METROPOLITAN GOVERNMENT OF NASHVILLE AND DAVIDSON COUNTY

STAFF RECOMMENDATION 2008 19th Avenue South February 19, 2014

Application: New construction-addition to outbuilding and conversion to detached accessory dwelling unit

District: Belmont-Hillsboro Neighborhood Conservation Zoning Overlay

Figure 1. 2008 19th Avenue South with the existing accessory structure marked with an arrow.

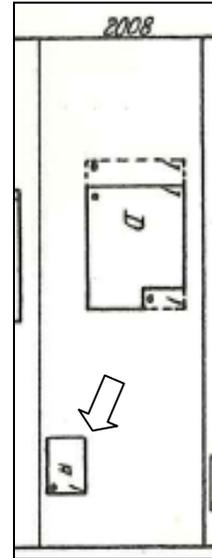
Background: The primary structure at 2008 19th Avenue South is a one-story frame bungalow constructed c. 1915 (Figure 1). It is a contributing structure to the Belmont-Hillsboro Neighborhood National Register district. The date of the existing outbuilding is unknown. It does not appear to be the same structure that appears on the 1957-61 Sanborn map, and the structure does not contribute to the historic character of the site or district (Figure 2 & 3).

1 North Elevation
Scale: 1/4"=1'-0"

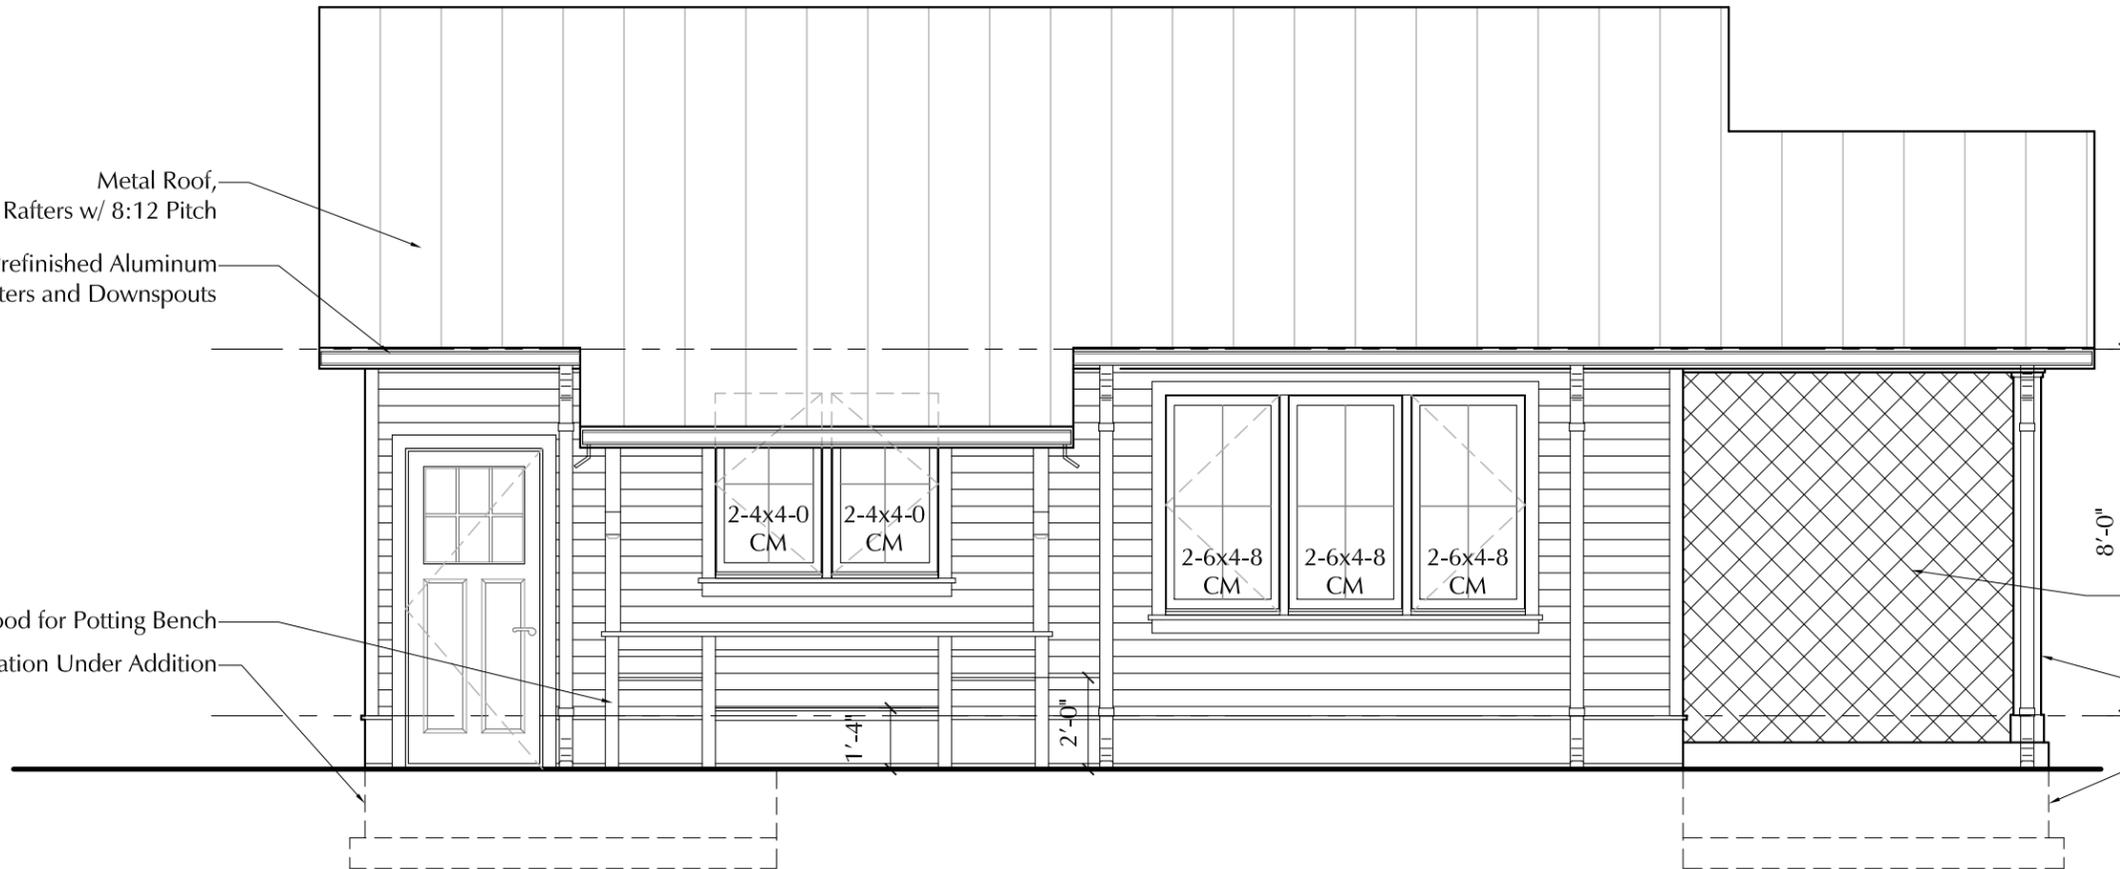
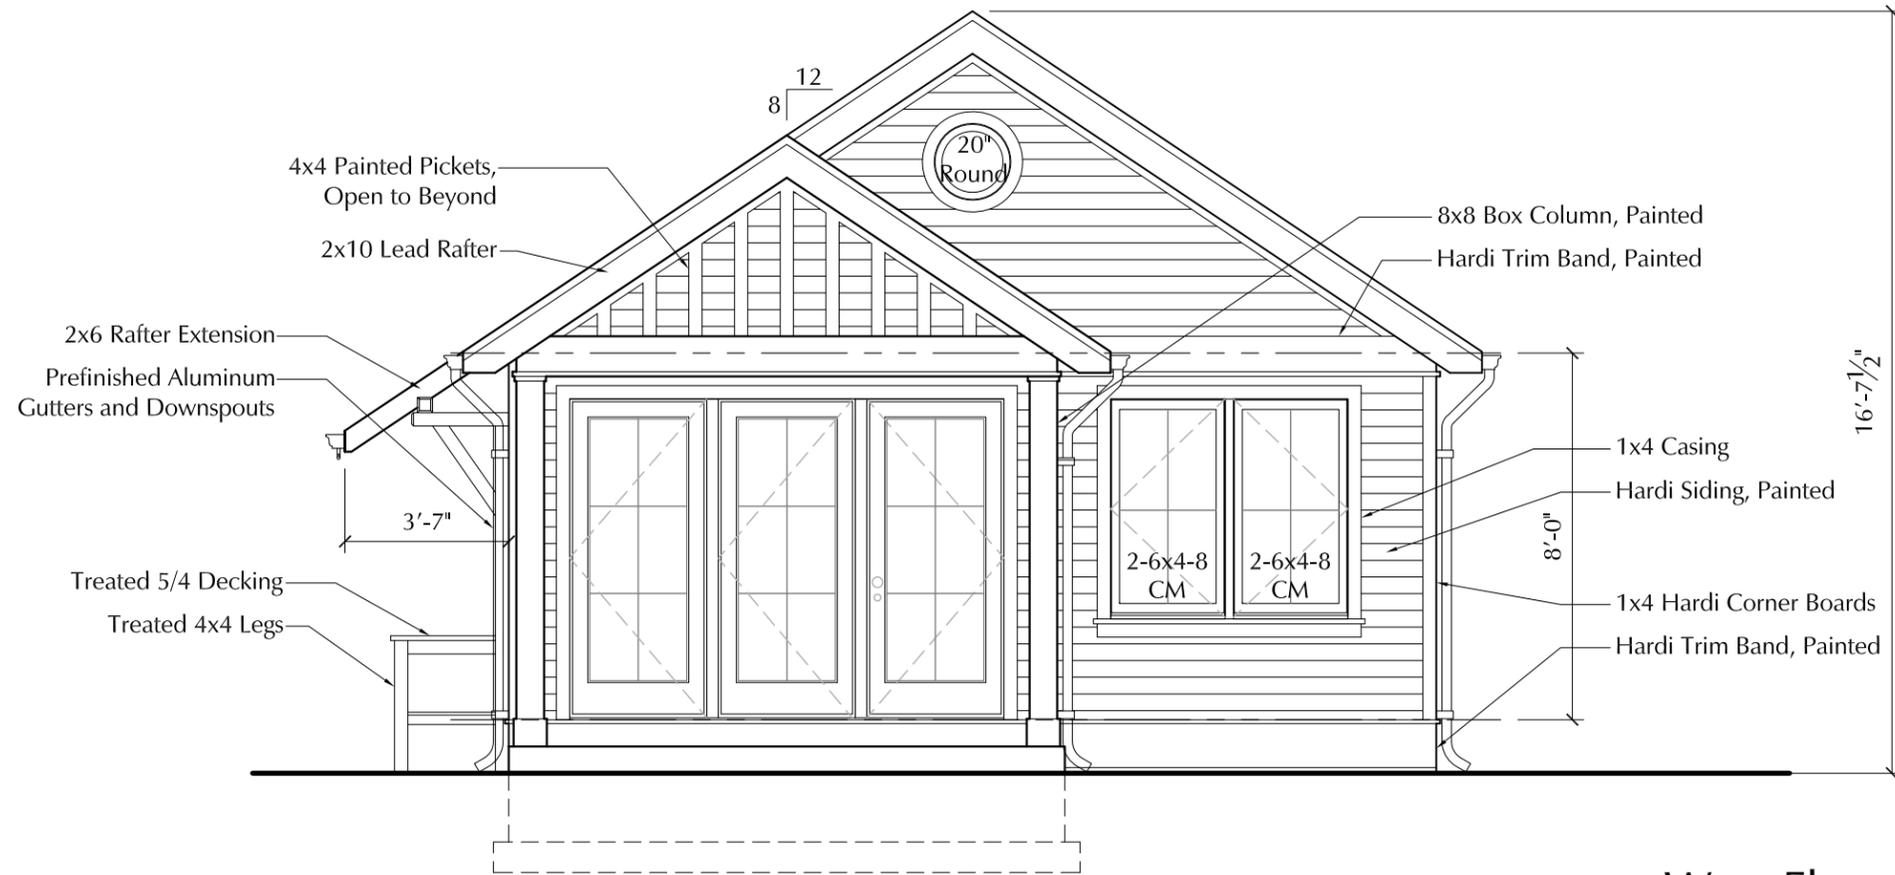
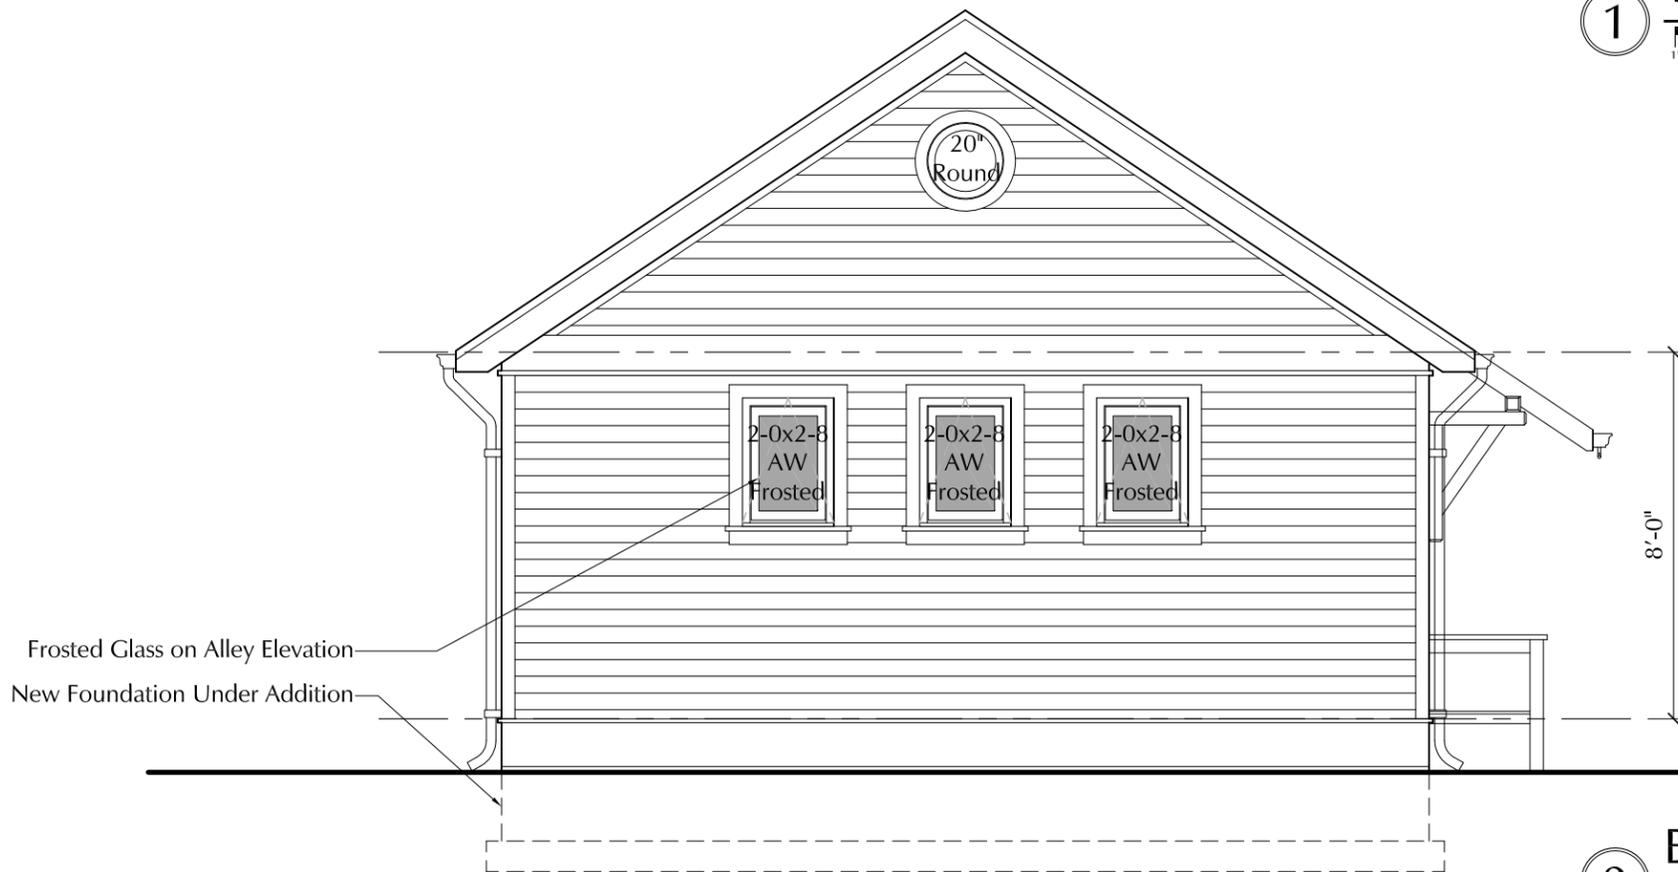
Design Standards. The accessory structure has a simple, utilitarian design that is appropriate for outbuildings. Its roof form, detailing, and form do not contrast greatly with the primary structure. Its roof form is a gable with an 8/12 pitch, and the roof does not contain any dormers. The fenestration pattern is appropriate for an outbuilding, except that the double and triple windows should have a four to six inch (4-6") mullion in between them. With the addition of four to six inch (4-6") mullions, the structure meets Standard 8 of the Detached Accessory Dwelling Unit regulations and Section II.B.1.i. of the design guidelines

Materials: The foundation is a concrete slab. The roof will be standing seam metal; Staff asks to approve the roof color. The cladding material will be cement fiberboard lap siding with cement fiberboard trim. The materials for the windows and doors were not specified, and staff asks to approve the windows and doors prior to purchase. Staff finds that the known materials meet section II.B.1.i. of the design guidelines.

1. The double and triple window openings have a four to six inch (4-6") mullion in between them;
2. Staff approve the metal roof color and all windows and doors prior to purchase and installation.
